VIRGIN ISLANDS WATER AND POWER AUTHORITY

PR-04-24

Underground Electrical Construction Hannah's Rest Phase 1

ADDENDUM II

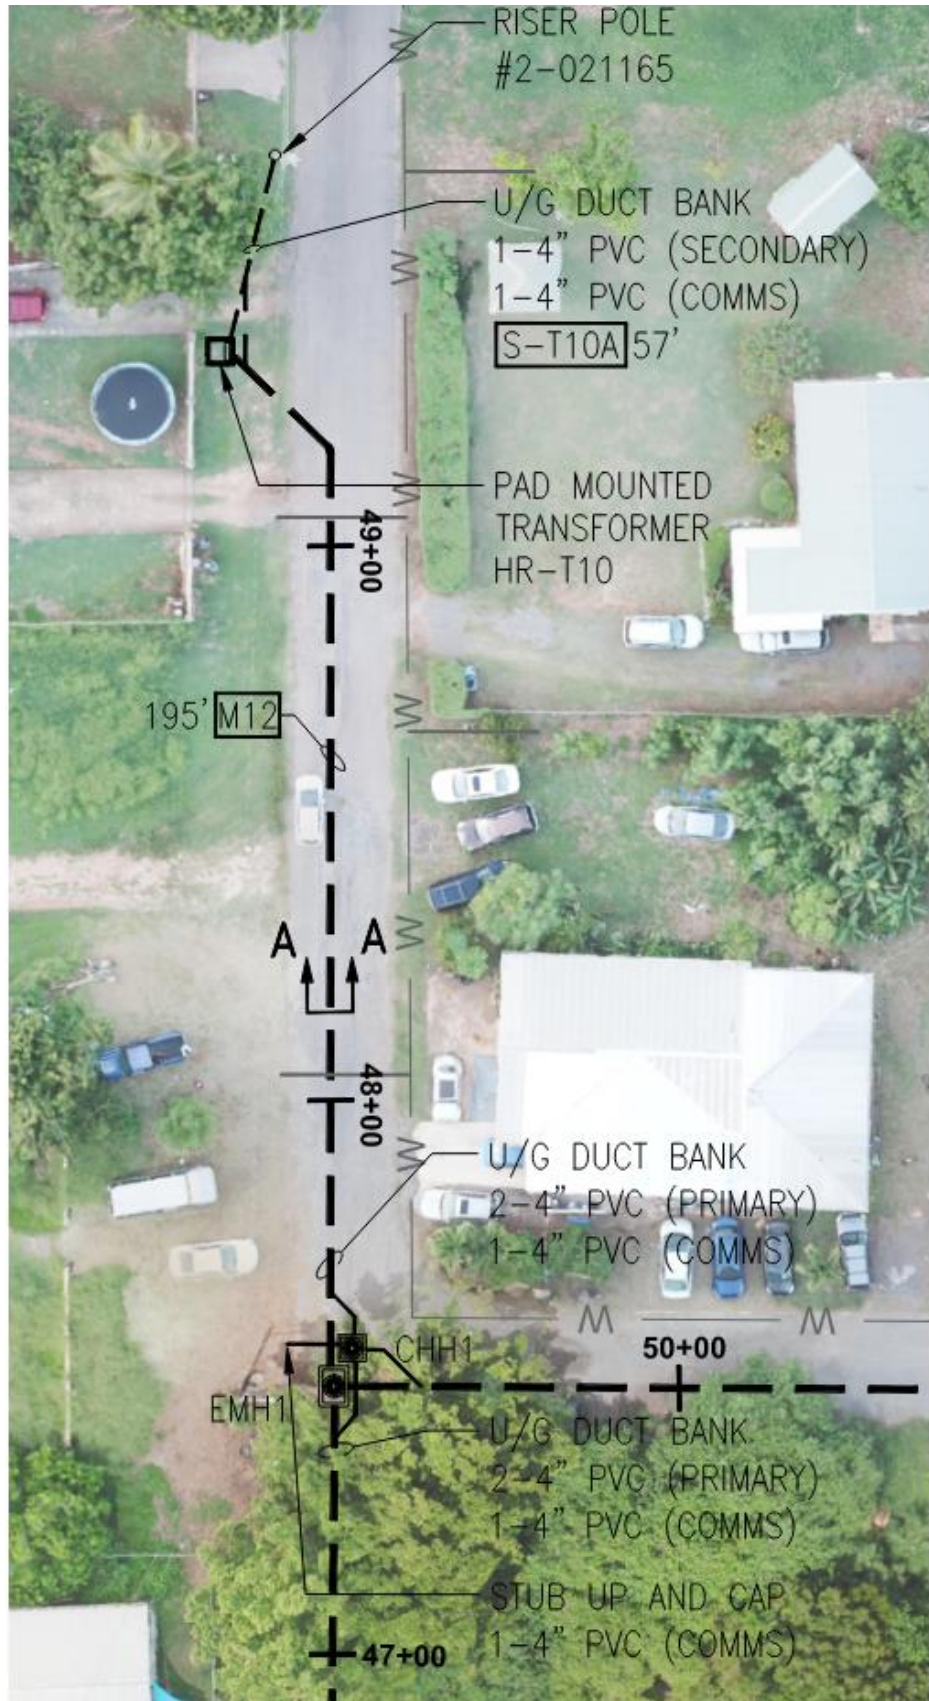
Question #1

The bid form currently has a quantity of 0 Linear Feet for Item 7-D – Duct Bank Section D-D 4-4" PVC (flow fill) under road but this duct bank section is needed at manhole EMH4; please clarify.

There are not 4-4" PVC at EMH4. There are 3-4" PVC (Section A-A), and 5-4" (Section K-K) plus 3-4" PVC stub outs. The scope of work for this project does not presently include PVC Section D-D duct bank.

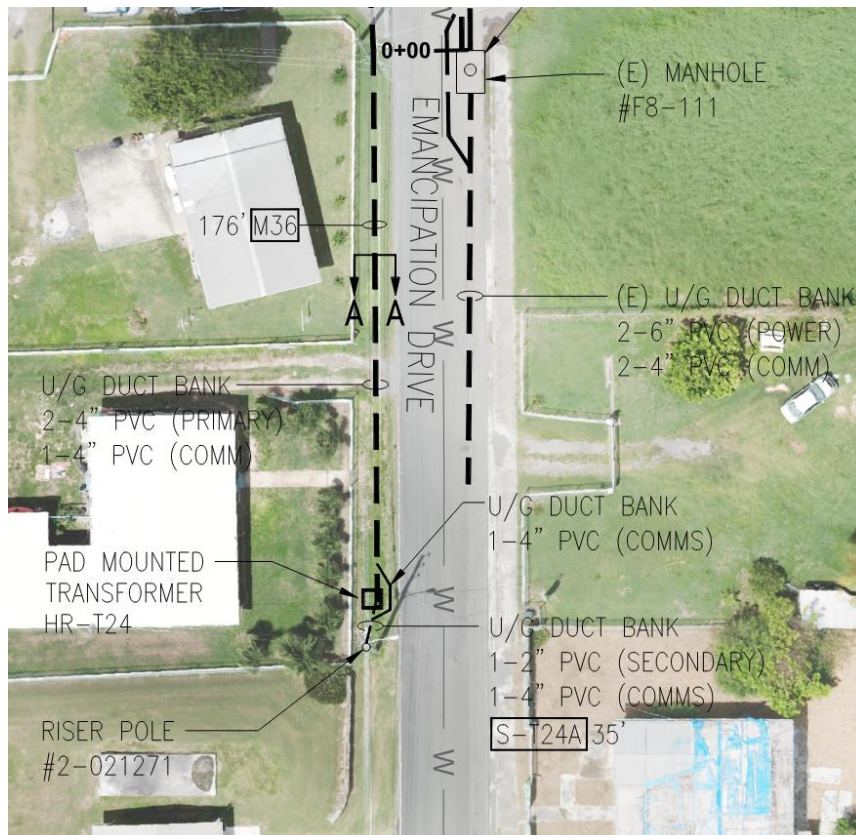
Question #2

On sheet STX-20131-HR-E-302 near station 48+00 the plans call for duck bank section D-D but also calls of 4-4" PCV (Primary) and 1-4" PCV (Comms) which is section K-K please clarify.

Section' A-A' is the correct section. This duct bank shall be 3-4" PVC. One conduit is spare, one conduit is for communications and one conduit shall include 2-1/C #1/0 cables (to and from HR-T10). See attached sketch on page 3.

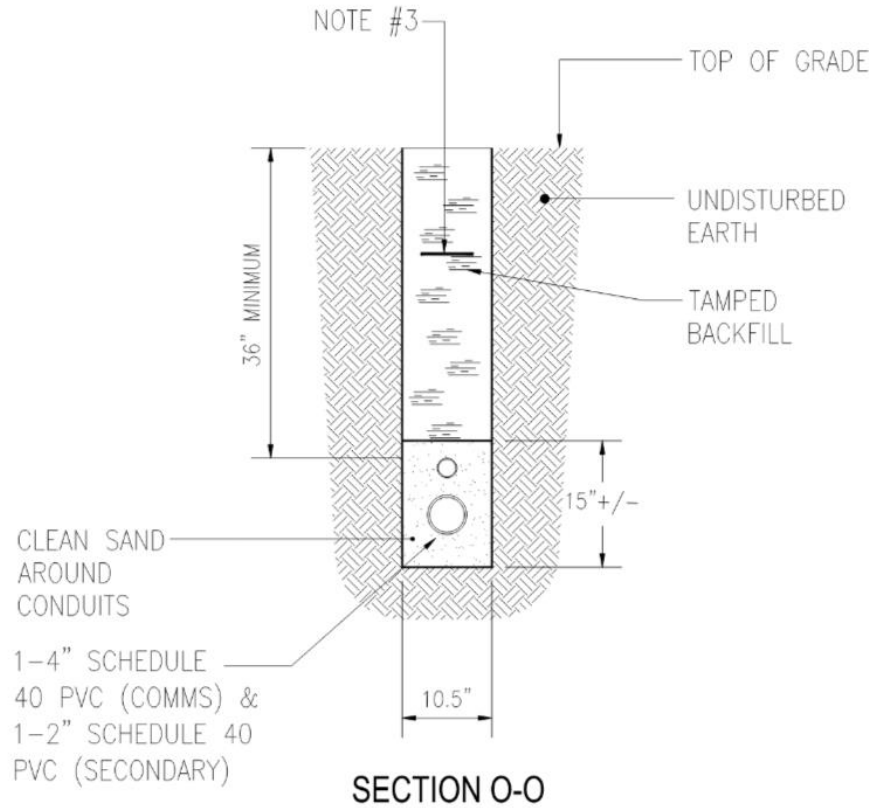
Question #4

On sheet STX-20131-HR-E-302 behind station 0+00 the plans call for 1-4” PVC (Comms) and 1-2” PVC (Comms) to be stub up and cap but it is unclear to what the conduits are stubbed up to as there is no pole or proposed equipment where they are shown; please clarify the work in the area around transformer HR-T24.

See revised sketch for clarification. The 1-2” PVC for communications has been eliminated. The new duct bank section O-O shown below shall be used for secondary and communications duct bank “S-T24A”.

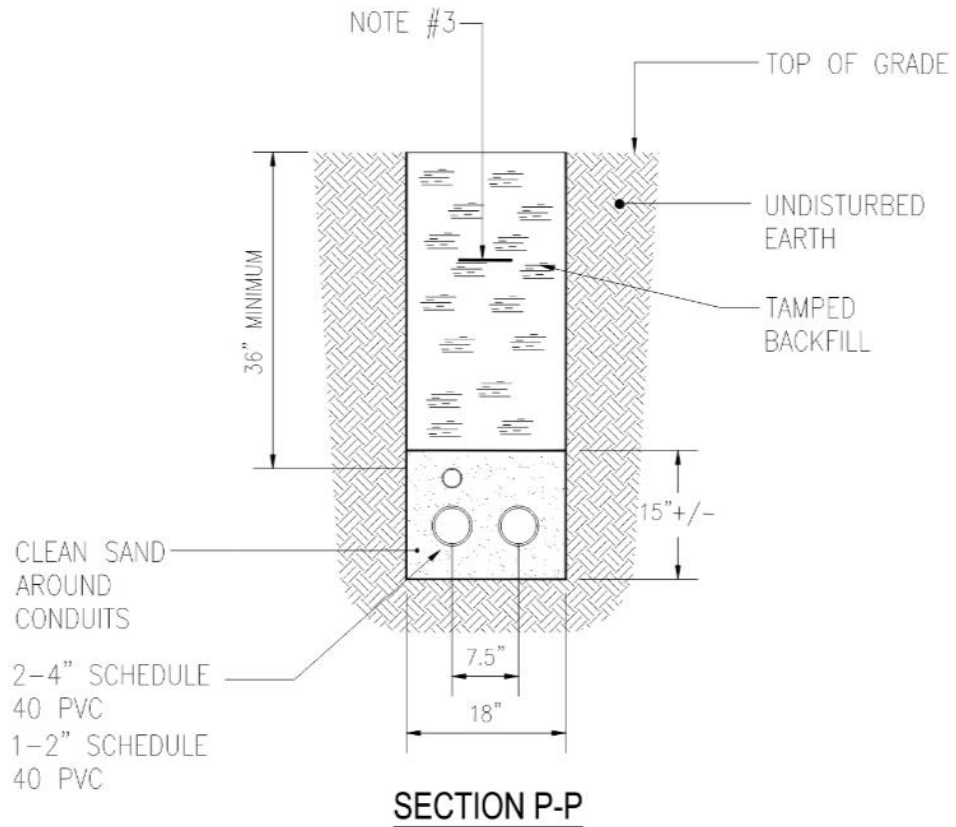
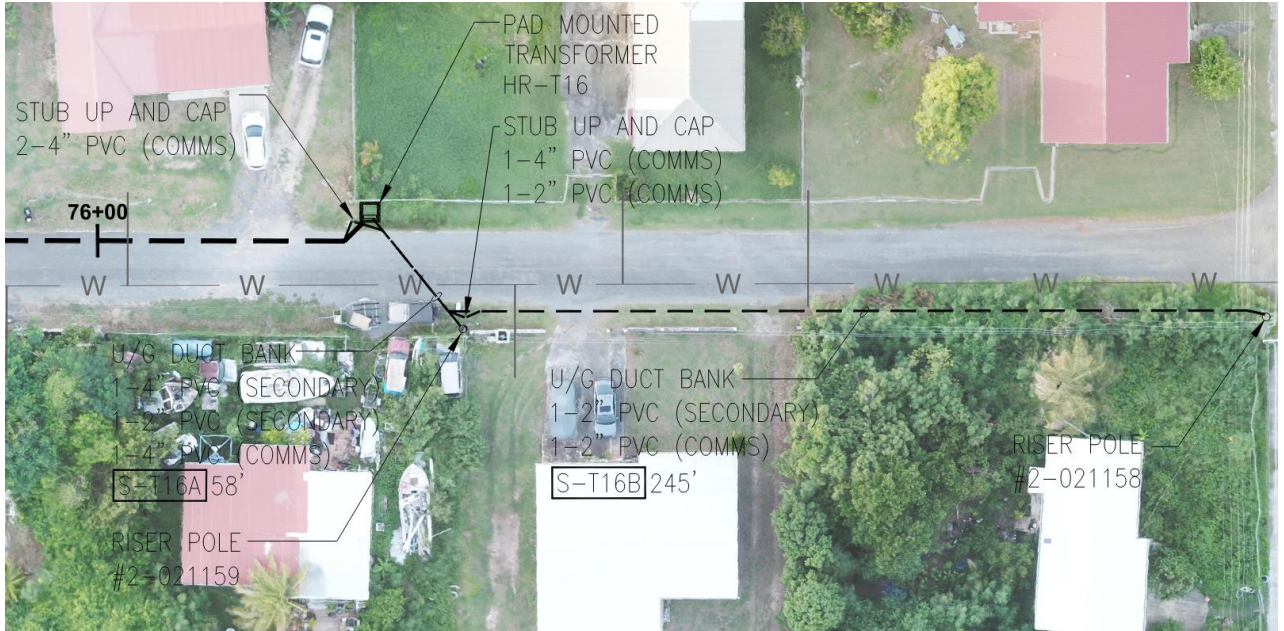
Question #5

On sheet STX-20131-HR-E-300 to the East of Riser Pole #2-021160 the plans call for 1-2" PVC (Secondary) and 1-2" PCV (Comms) to come out of a 1-4" PCV (Primary) and 1-4" PCV (Comms) duck bank; please clarify how these are connected to each other.

See attached sketch for clarification/modification. The new duct bank section P-P shown below shall be used for secondary and communications duct bank "S-T16A". Please refer to the updated Bid Form attached.

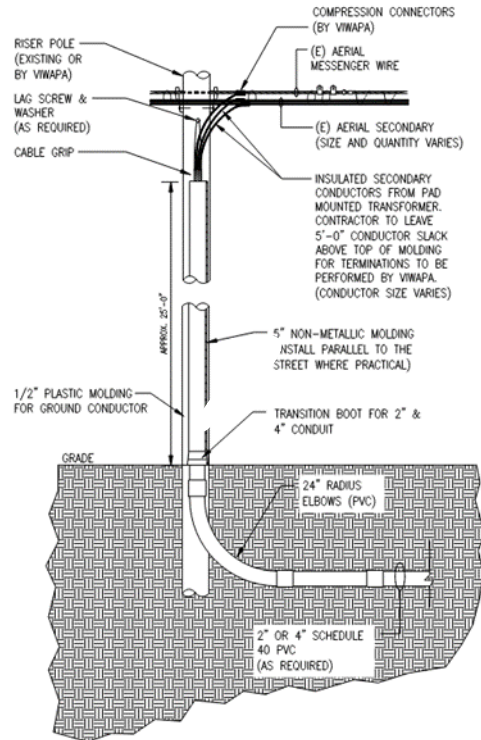
Modification #3:

Replace the secondary riser pole base detail on Drawing #E-102 with the following detail:
